Appl. No. 10/645,966
Amdt. dated Jan. 28, 2005
Reply to Office action of Dec. 7, 2004

Appl. No. 10/645,966
Amdt. Dated Jan. 28, 2005
Reply to Office action of Dec. 7, 2004
Annotated Sheet Showing Changes

FIG.2

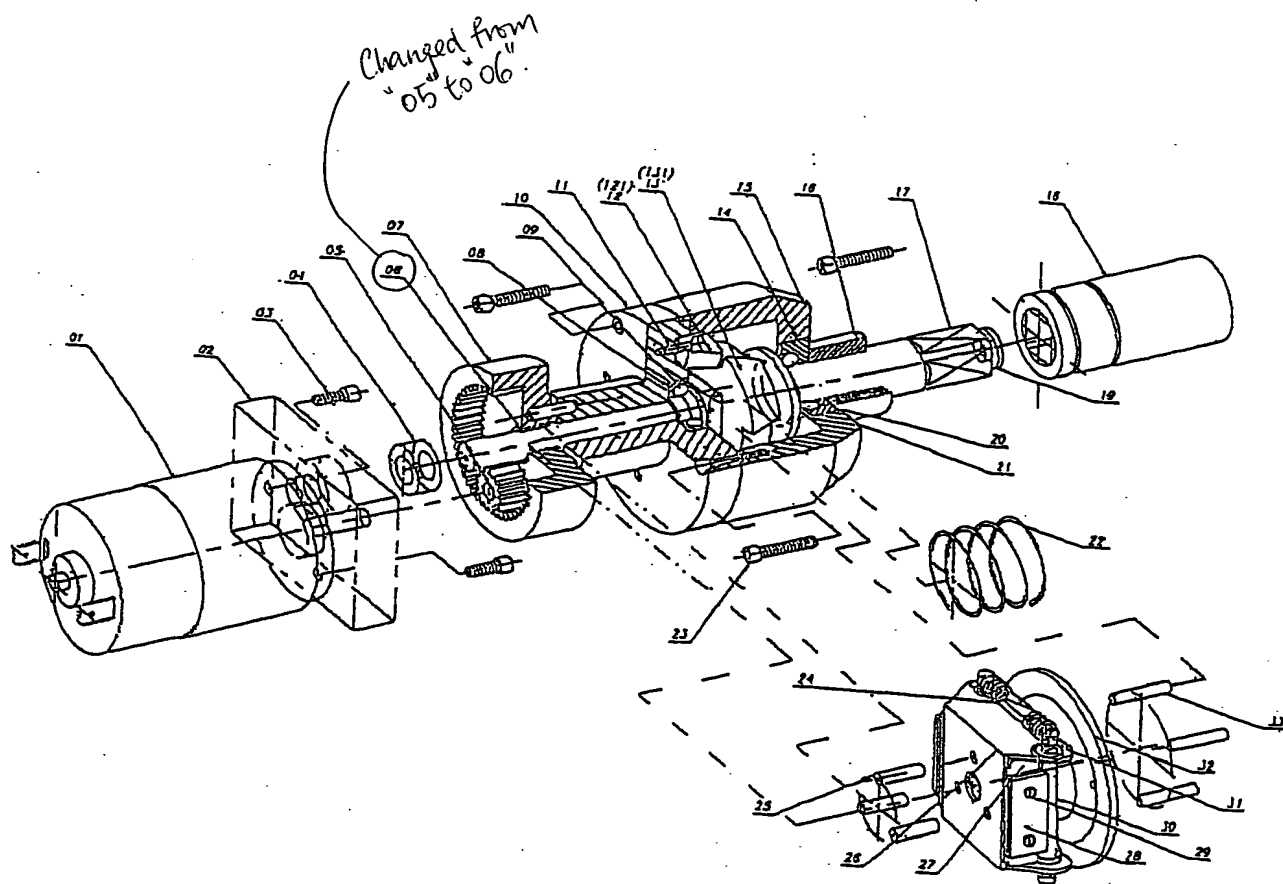
In amended Fig. 2, one of the original reference numbers 05 has been amended to 06.

The examiner also considers that the clutch bracket (6) is stated to have "at least one hole" in the claims and that from the drawings it appears that it can have only one hole, and thus the specification and claims are not supported by the drawings. Please kindly take note that the reference number for the clutch bracket should be (26) instead of (6). According to Fig. 2, there are 3 holes on the clutch bracket (26) for 3 set pins (25) to go through. It should be obvious to a person skilled in the art that the number of set pins can vary and thus the number of holes on the clutch bracket can also vary. Therefore, the drawings should be able to support the claim that the clutch bracket has at least one hole. I trust that your objection to my claim on the part of the clutch bracket should be a misunderstanding caused by the typo in the specification. I apologize for any inconvenience caused.

The attached sheet of drawings includes changes to Fig. 2. This sheet, which includes Fig. 2, replaces the original sheet including Fig. 2. In Fig. 2, one of the original reference numbers 05 is changed to 06.
